Docket Item # 2  
BAR CASE # 2011-0132

BAR Meeting  
June 15, 2011

**ISSUE:** Fence Removal and Reconsideration of Window Installation

**LOCATION:** 426 North Columbus Street

Figure 1: Site Plan

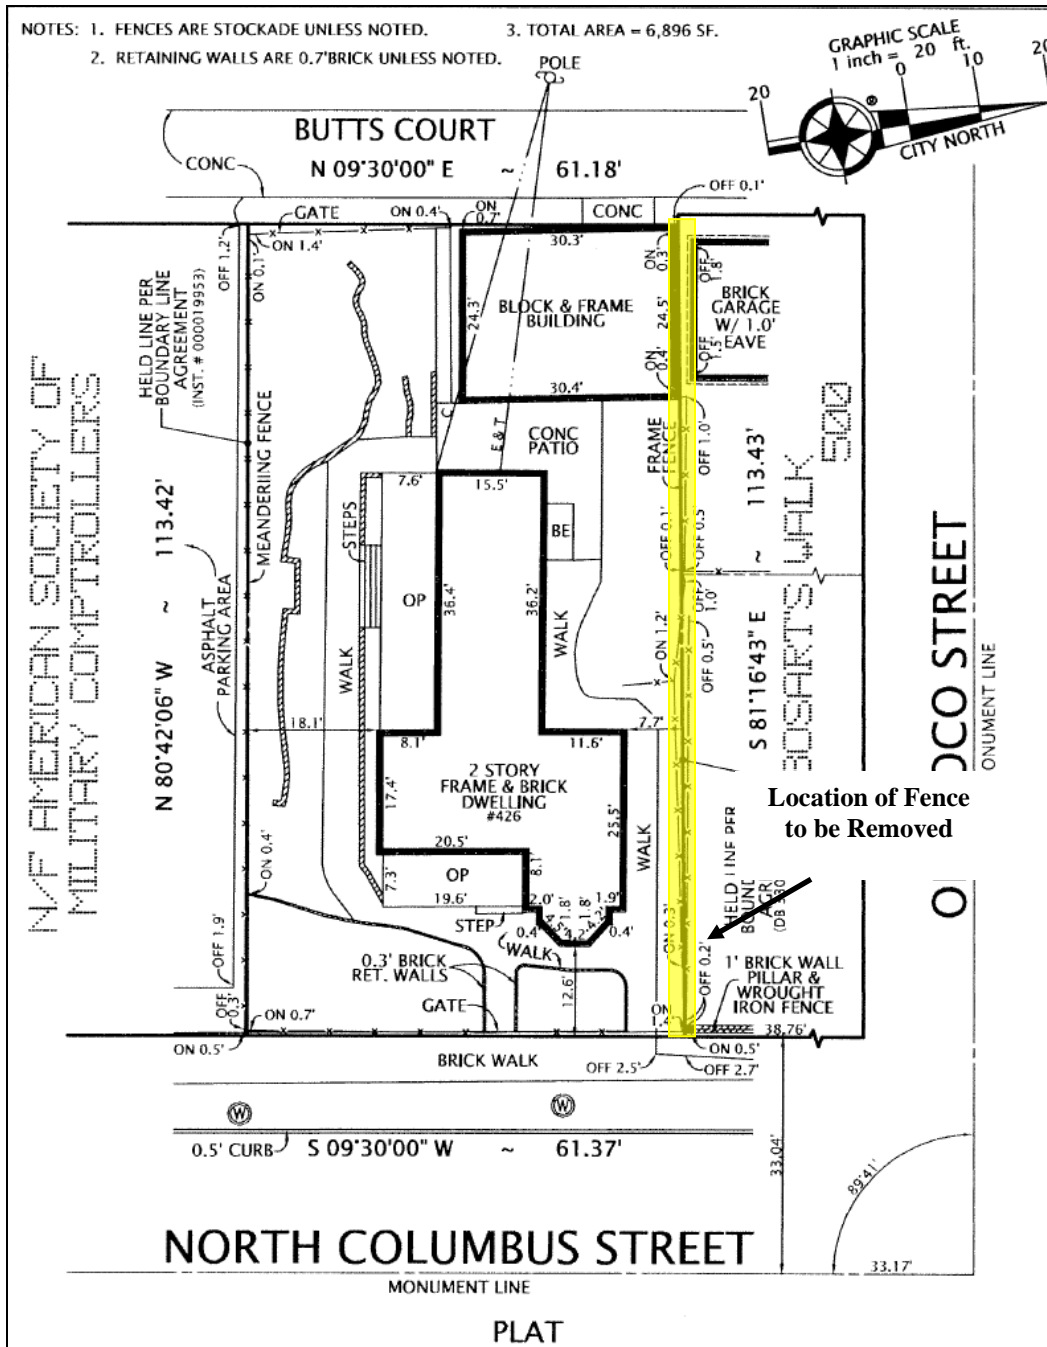
If the Board supports installation of the two new windows, staff recommends that the sash be a 1/1 or 2/2 muntin pattern, that the profile of the window trim be slightly differentiated from the historic windows and the window balance mechanisms are modern and do not utilize a weight and chain system.

Staff supports the removal of the chain-link and 6’ high picket fence as these fences are not compatible with the existing mid-19<sup>th</sup> century dwelling.

1. That the sash be a 1/1 or 2/2 muntin pattern;
2. That the profile of the exterior window trim be slightly differentiated from the historic windows; and
3. That the window balance mechanisms are modern and do not utilize a weight and chain system.
